Date: 6 March 2006
 To: T10 Technical Committee
 From: Ralph O. Weber
 Subject: SAS-2 Zoning - Phy Features

During the February 23 SAS Supervisor meeting (minutes in 06-114) it was suggested that 06-107 and 06-048 be combined in a single document covering all SAS-2 Zoning changes related to the physical level. This document is that combination.

Proposed SAS-2 Changes

Figure n1 — Example of a ZPSDS with the ZONE ADDRESS RESOLVED bit set to zero

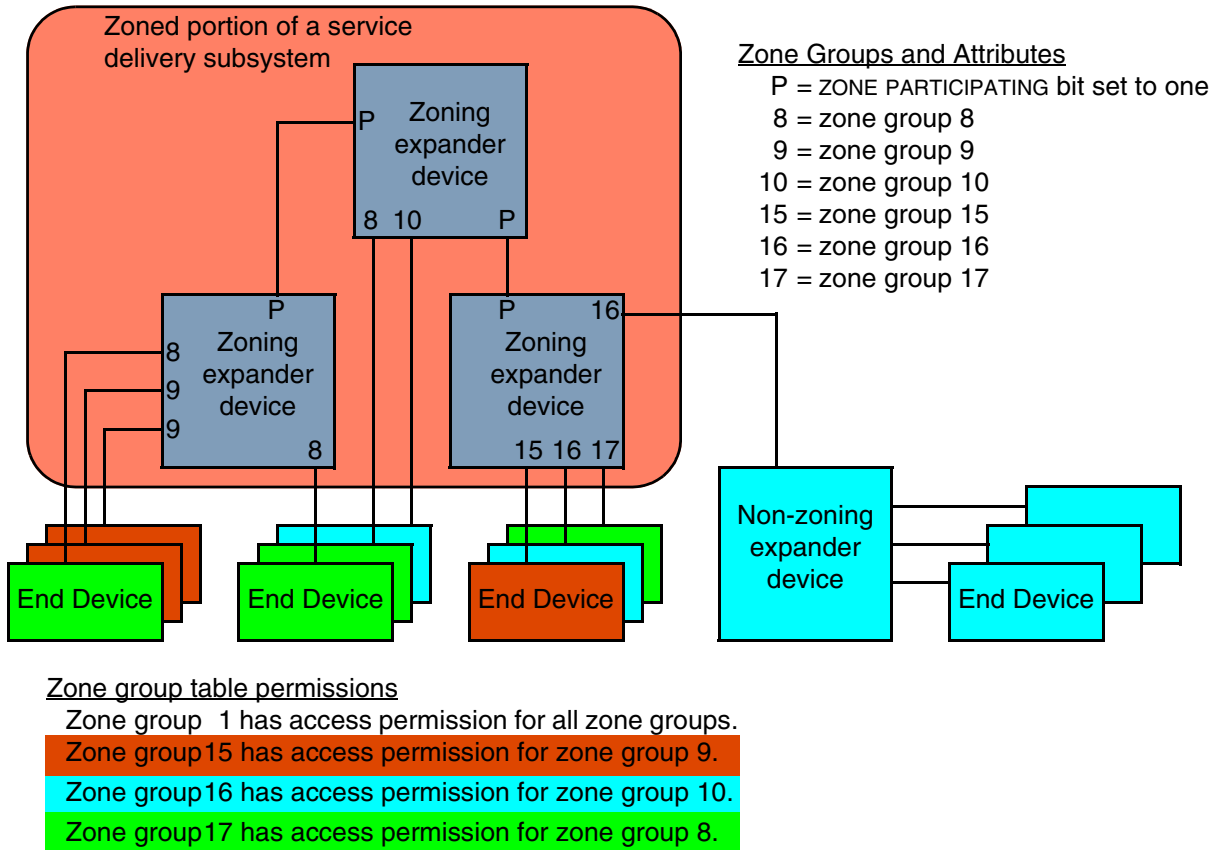
Figure n1 shows an example of a ZPSDS in which the zoning expander devices all have the ZONE ADDRESS RESOLVED bit set to zero.

Figure n2 — Example of a ZPSDS with the ZONE ADDRESS RESOLVED bit set to one

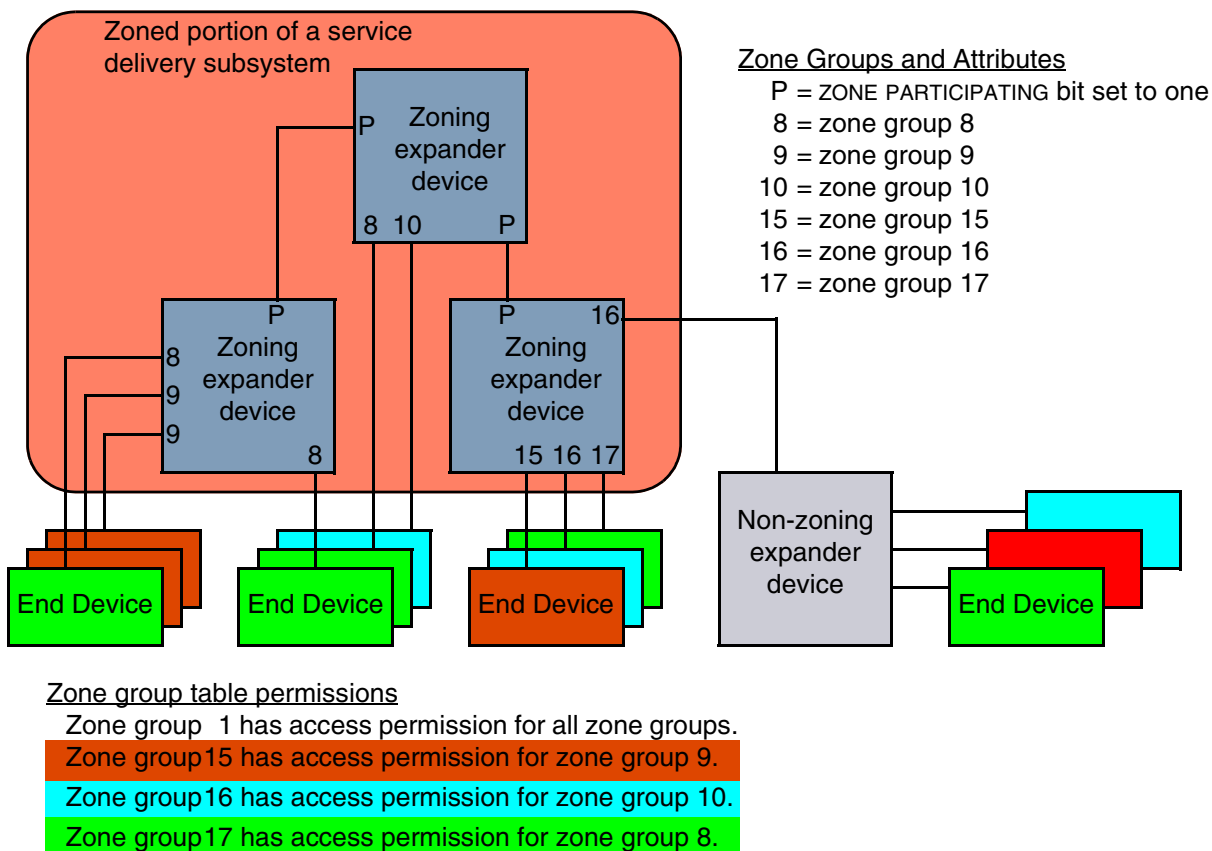
Figure n2 shows an example of a ZPSDS in which the zoning expander device connected to the non-zoning expander device has the ZONE ADDRESS RESOLVED bit set to one.

Figure n3 — Zoning expander route table example

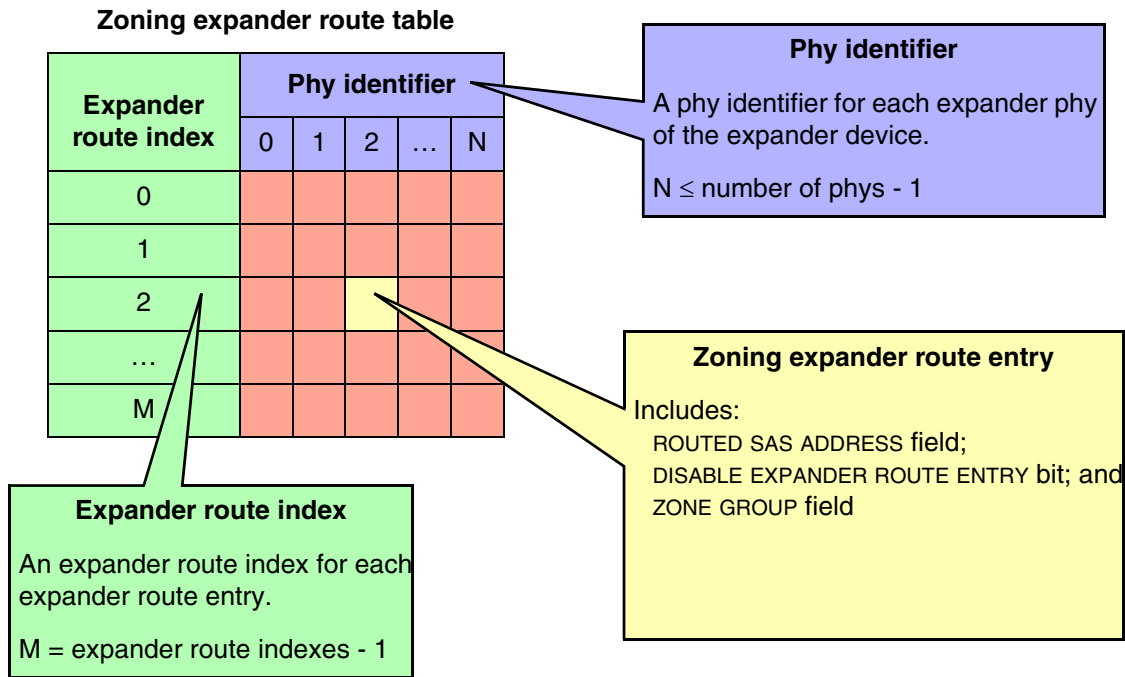
The zone route table in a zoning expander device shall contain zone phy information in addition to the expander phy information.

Figure 2 shows a representation of a zoning expander route table.
